**Re: PART 573 NOTICE RE BELLOWS PIPE ON 2012 - 2013 MCI D SERIES**  
**COACHES WITH CUMMINS 2010 ISX ENGINE**

Safety Defect and Noncompliance Report Guide for Vehicles  
**PART 573 Defect and Noncompliance Report**

**MCI Service Bulletin 397**

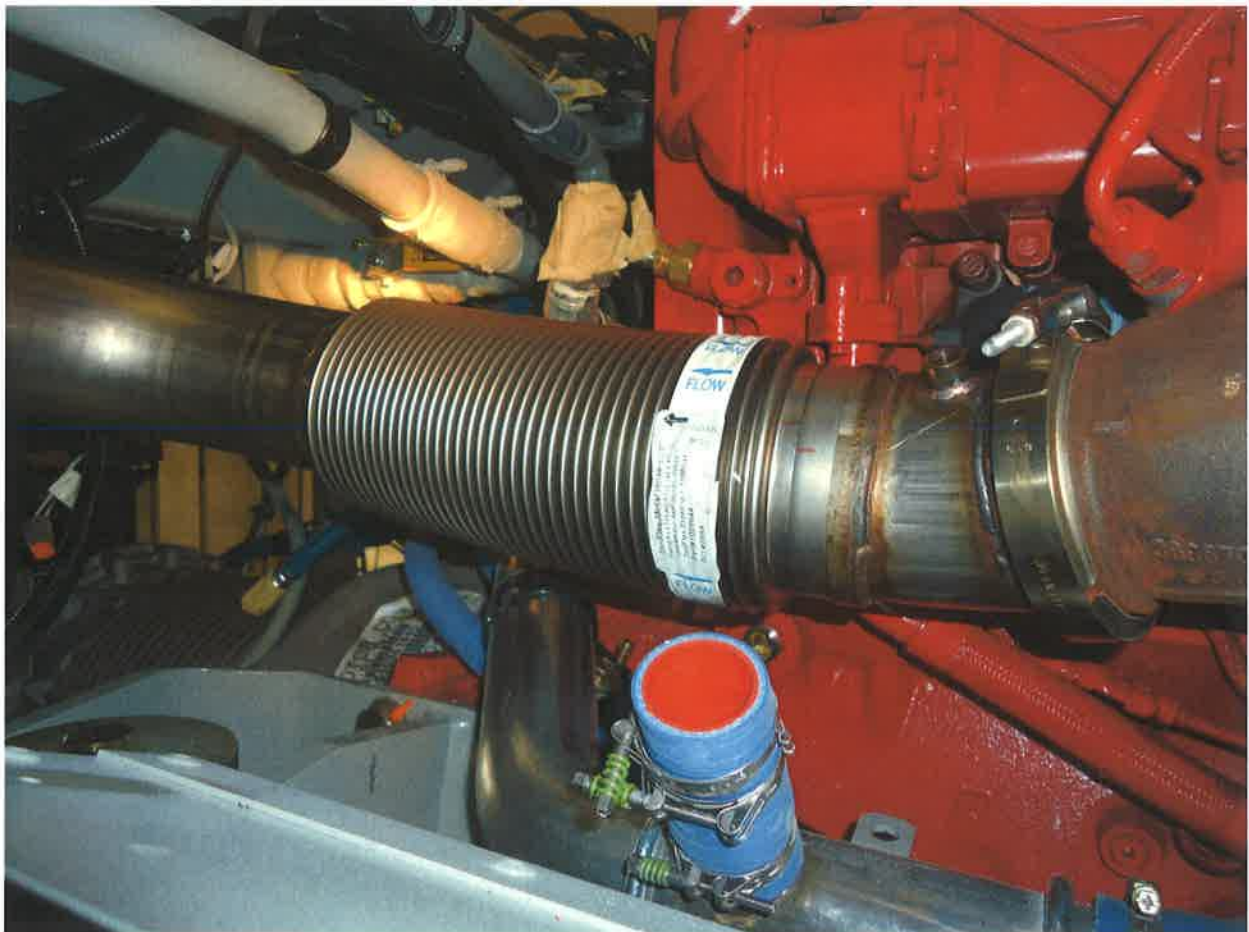
Coaches manufactured prior to the recall population had a different configuration for the exhaust system that is not susceptible to the defect. MCI implemented a configuration change to the exhaust system with the implementation of the 2010 EPA Engine. MCI has identified a potential incorrect installation of the bellows pipe, which is one of the components of the exhaust system, beginning with VIN 12690. If the bellows pipe is installed incorrectly, the pipe may become deformed. If the deformation is too large, the bellows pipe may prematurely fail as a result of metal fatigue. Coaches built after unit 12847 are not included in the recall because MCI changed the process for installation of the bellows pipe.

The bellows pipe is shown in the picture below:

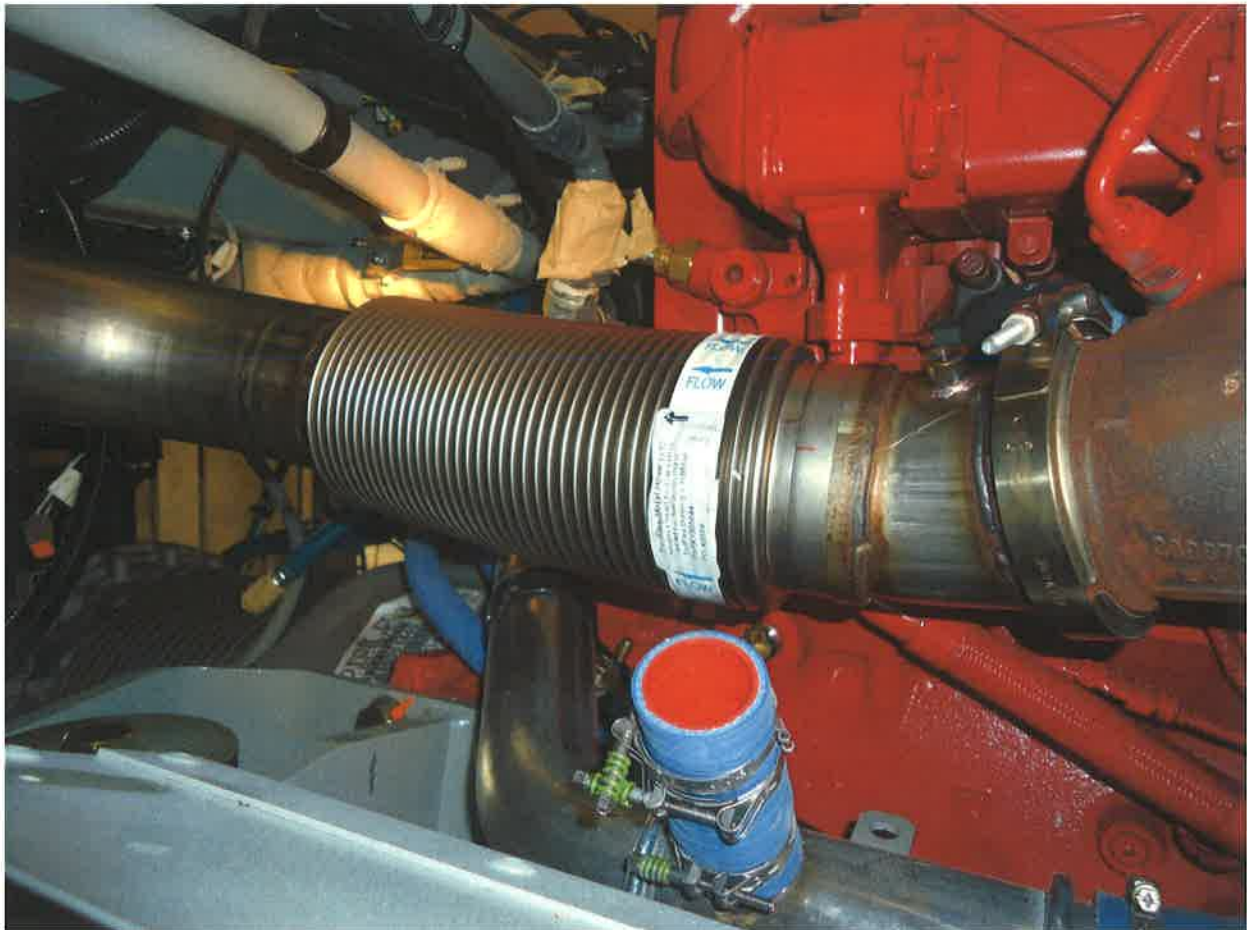
MCI identified an incorrect assembly process related to the installation of the bellows pipe, which is a component of the exhaust system. The incorrect assembly process may cause deformation of the bellows pipe that could potentially result in a failure of this pipe during operation. The exhaust system of the Cummins EPA 2010 engine automatically undergoes a regeneration process that clears soot from the Diesel Particulate Filter ("DPF", which is another component of the engine exhaust system). The regeneration process involves the injection of diesel fuel into the DPF and the subsequent combustion of this fuel clears the soot from the DPF. This process is intended to be completely contained within the exhaust system. However, if the bellows pipe fails and a regeneration event occurs, the combustion may not be completely contained within the exhaust system and could potentially exit the

**bellows pipe. If this occurs, the hot combustion gases could cause a fire, potentially resulting in personal injury and/or property damage.  
When the bellows pipe is incorrectly assembled it can be deformed as shown in the following picture:**

In March and April 2013, MCI became aware that two MCI D coaches had sustained fire damage. MCI's investigation revealed that the damage had resulted from an active regeneration event and the presence of a cracked bellows pipe. The cracked bellows pipe allowed combustion products to escape the exhaust system, causing damage to surrounding material.

**MCI will provide, at no cost to customers, the parts and labor to inspect and replace as necessary any failed or deformed bellows pipes. The procedure will be further described in MCI Service Bulletin 397, to be sent under separate cover.**

**The rework will result in the proper assembly and alignment of the bellows pipe, which will avoid or reduce the likelihood of a thermal event. The picture below depicts the correct installation:**
